Updated Software (APU & DCP) for the ComfortPro APU

IMPCO has implemented updated firmware software on all units manufactured as of January 2016 with S/N ETD2220943 or later. These software updates have **not** been applied to Service Parts.

Software by APU Serial Number

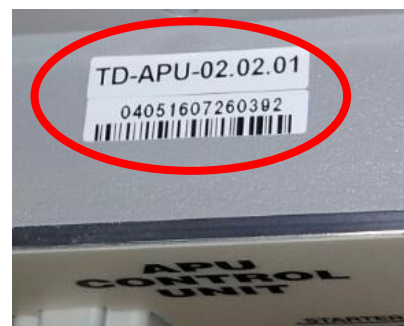
Device Label	Software	Notes:
APU "04A" 	APU 04.04A.hex	S/N after NXC98206420, prior to s/n ETD2220942; (Closed Sensors)
APU "04A" with green dot 	TD-APU-02.02.01.hex	S/N ETD2220943 or later

Device Label	Software	Notes:
DCP3 "S/W Rev 02C" 	DCP3 019.02C.hex	S/N after NXC98206420, prior to s/n ETD22220942
DCP3 "S/W Rev 02C" with green dot 	TD-DCP-02.02.01.hex	S/N ETD22220943 or later
